S i d e E l e v a t i o n - 1 F a c i n g W e s t

Project:
PLOT KNOWN AS
11, SLATHWAITE DRIVE, MANCHESTER, M11 4BA.

PROPOSED DWELLING.

2017 AL(4-)04

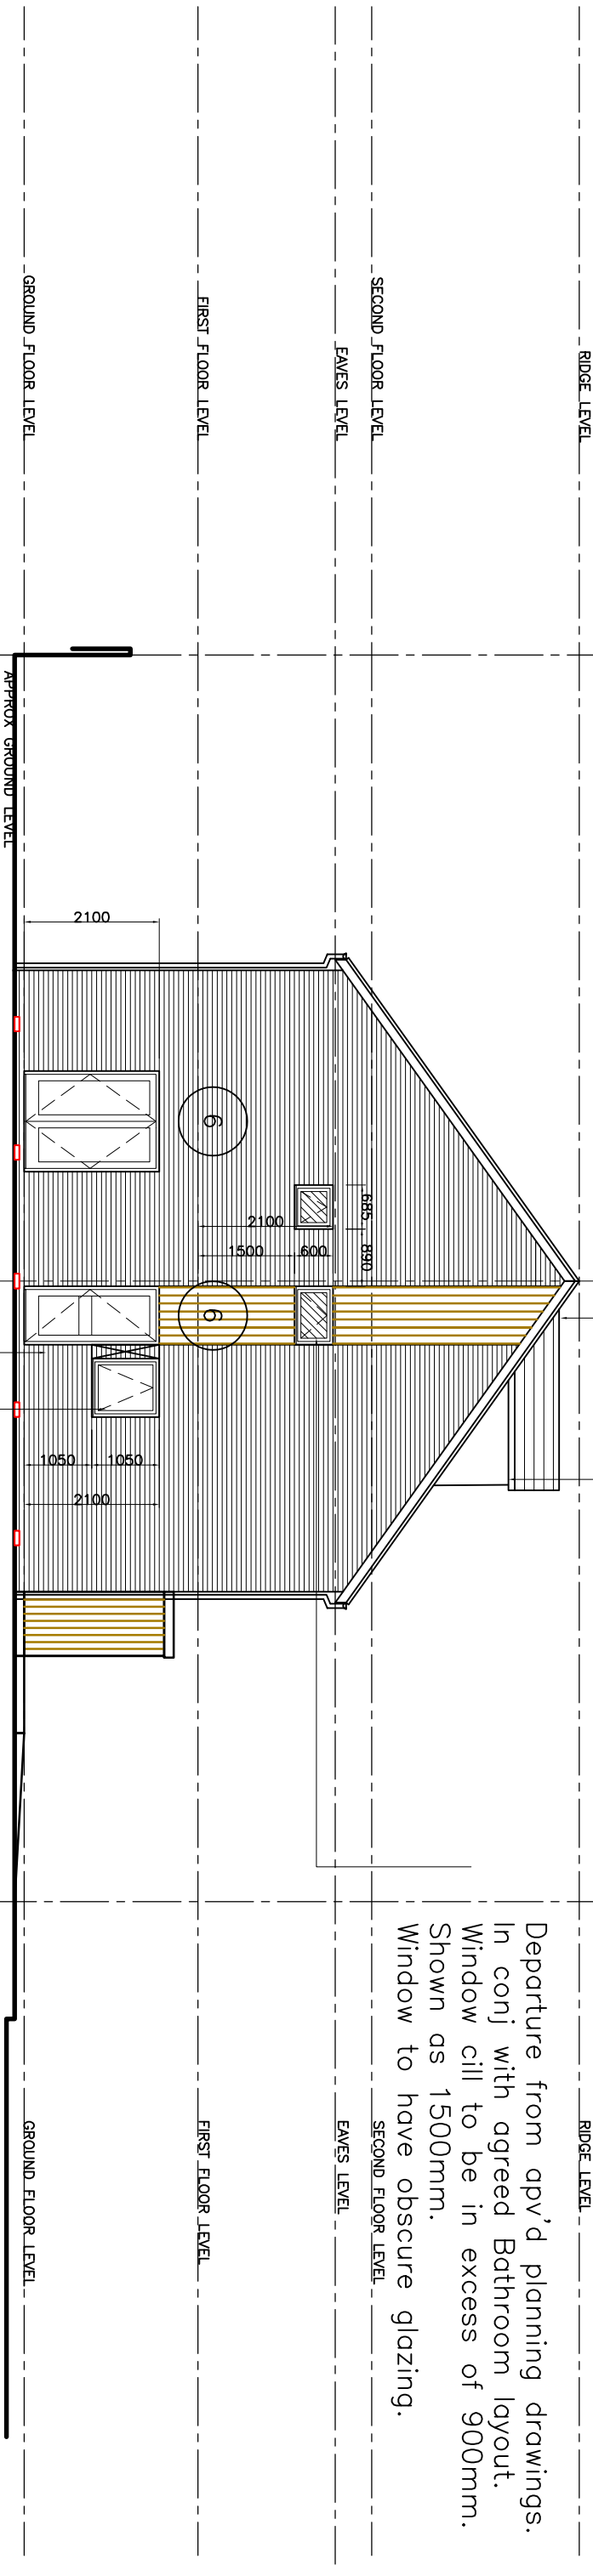
Approved planning drawings suggest stained sw. cladding to line shown.
Agree spec.
Brickwork not required behind.
Provide blockwork where possible.
Fixed to horizontal treated sw battens.
Ensure ventilation and insect mesh.

DORMER.
Lead covered cheeks.
Matching roof finish.

Departure from apv'd planning drawings.
In conj with agreed Bathroom layout.
Window cill to be in excess of 900mm.
Shown as 1500mm.
Window to have obscure glazing.

Lintol section to span door and window.
Coordinate panel "crossed".
Integration of aluminium trim with adjoining window units.
READ IN CONJ WITH
GA GROUND FLOOR LAYOUT.

ENTRANCE PORCH AND EXTERNAL BIN STORE
DETAIL TO BE AGREED.

Ensure 1050mm cill height to suit kitchen fittings
